SERVICE BULLETIN #49

SUBJECT: A740-1 Manifold Pressure Line

ROTORCRAFT AFFECTED: S/N 002 thru S/N 545

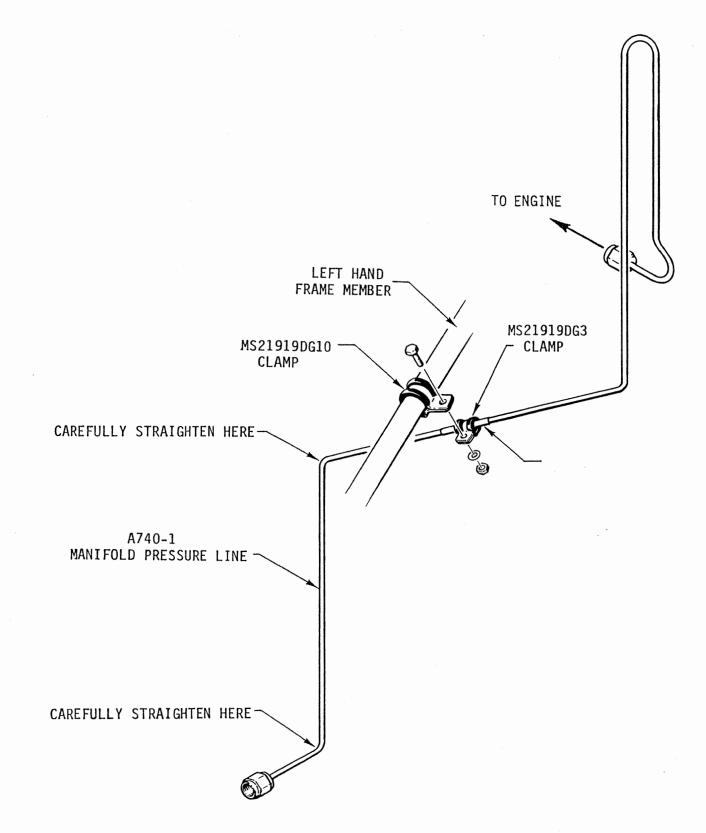
BACKGROUND: Chafing of the A740-1 Manifold Pressure Line has occurred on several helicopters. This chafing has occurred under the MS21919DG3 clamp that supports the Manifold Pressure Line. An erratic or high Manifold Pressure reading may occur if the chafing continues through the line.

4. Carefully straighten the two lower bends in the Manifold Pressure Line just enough to slide the flare nut fitting over them. Refer to the enclosed drawing.

6. Slide the 1.5 inch piece of heat shrink over the lower end of the Manifold Pressure Line. Position the heat shrink over the supporting clamp position marked in Step 1.

9. Install a new MS21919DG10 clamp over the steel frame member. Install a new MS21919DG3 clamp over the heat shrink and the line. Connect the two clamps with the existing hardware.
